ADDENDUM TO REQUEST FOR PROPOSALS

Well 31 Solar Panel Installation
RFP NO.: 611-W-058

ADDENDUM NO.: 1

COPYRIGHT 2011 Larson & Darby Group	DRAWN	PROJECT NO.	PHOTOVOLTAIC SYSTEM FOR CITY OF ROCKFORD BELL SCHOOL RD PUMP STATION, ROCKFORD, IL	DATE	SHEET NO.
	RAB	21058		04-20-2011	E-001

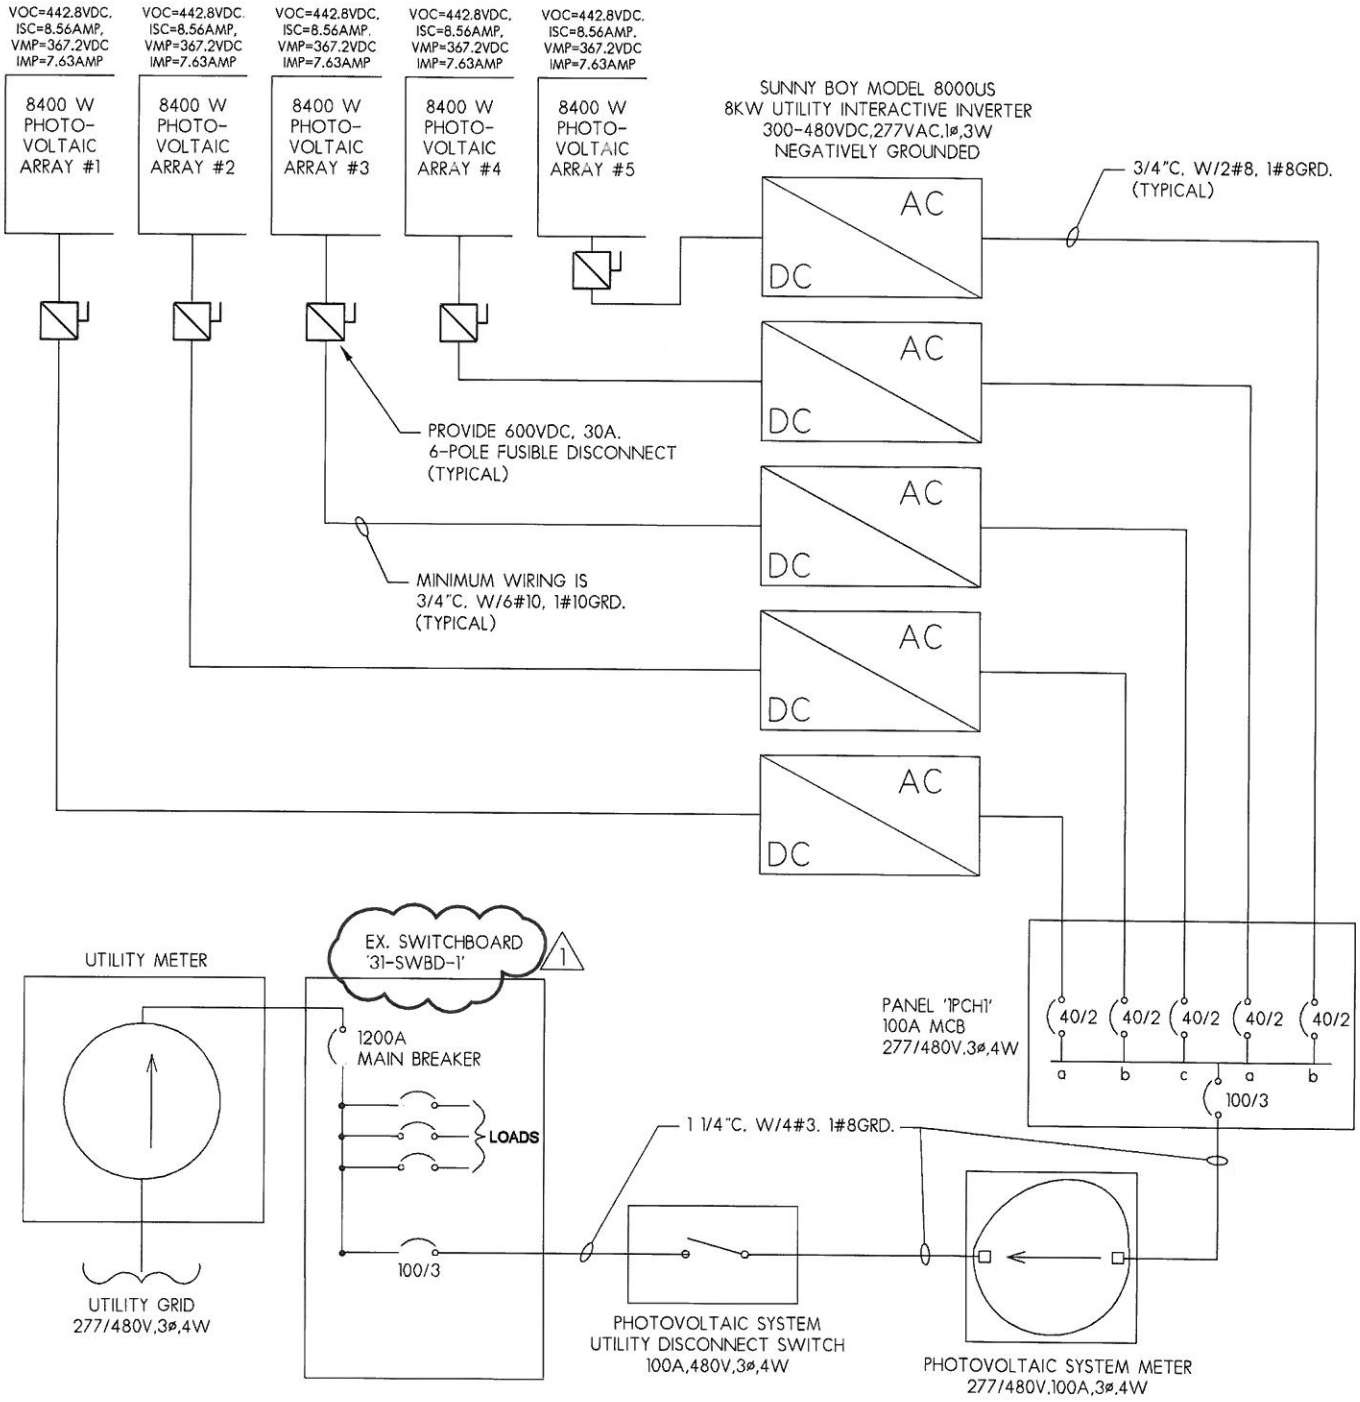
1. Remove the existing Exhibit A-I pages 13, 15 and 16 and replace with revised Exhibit A-I pages 13, 15 and 16 attached. Revised exhibits cover electrical connection to existing power panel SWBD-1 in the prepared spare breaker space.

NOTE:
ALL ROOFTOP WIRING SHALL BE TYPE THWN2 COPPER CONDUCTORS IN IMC OR RGS CONDUIT.

1 ADDENDUM #1 - 06/09/11

ELECTRICAL
1-LINE DIAGRAM

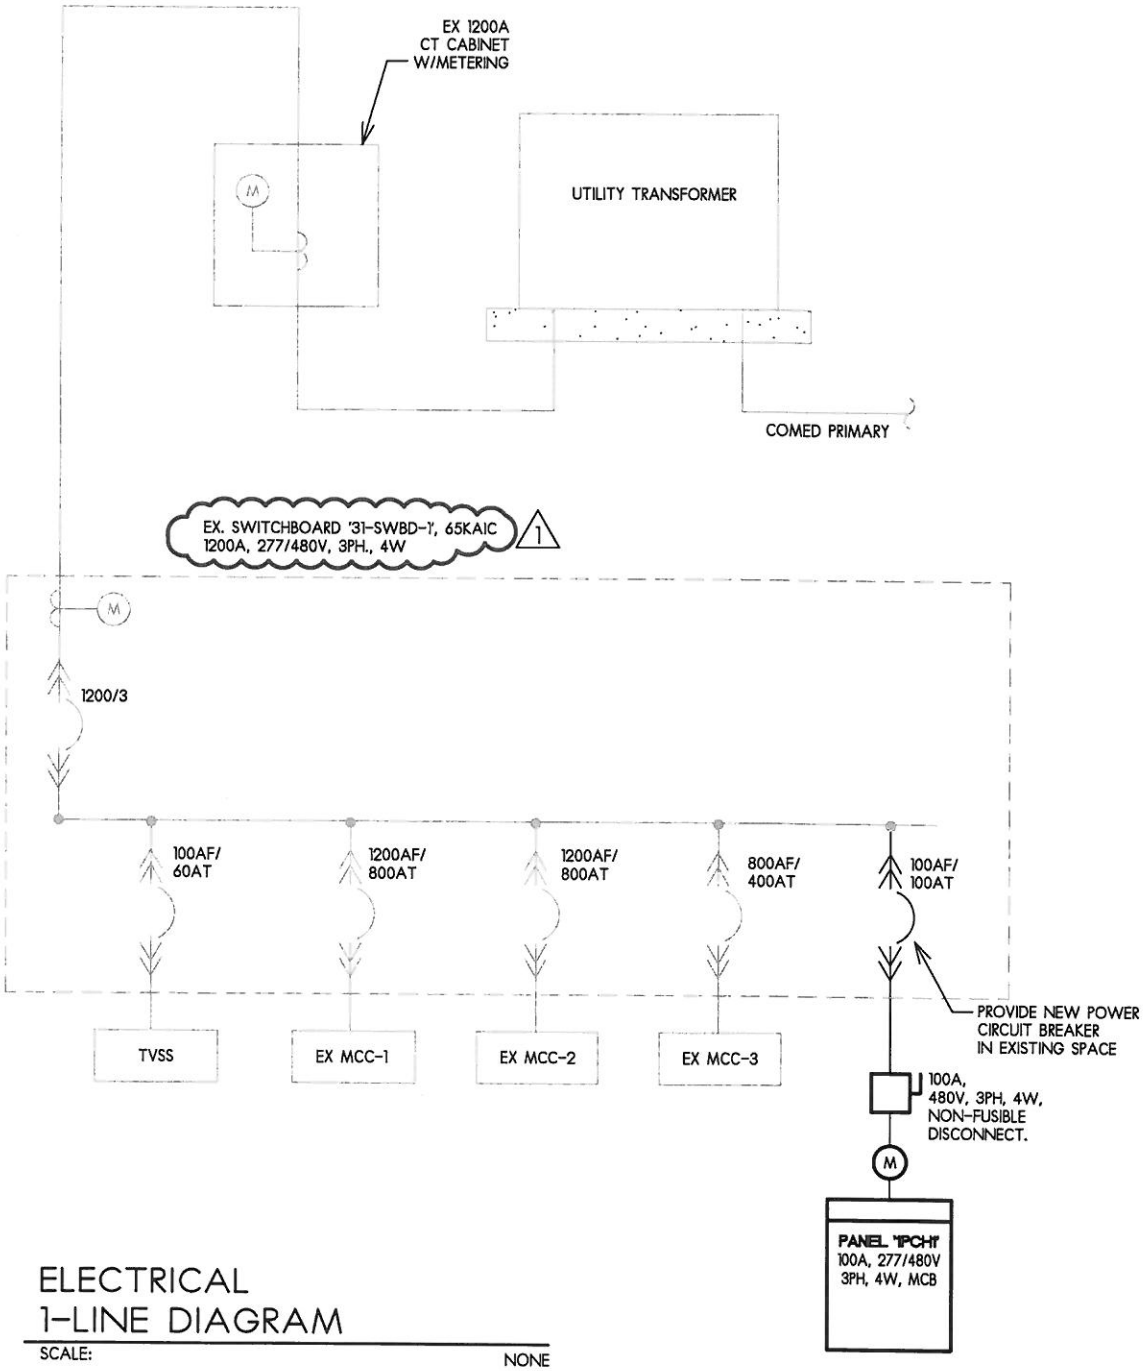
1 ADDENDUM #1 - 06/09/11
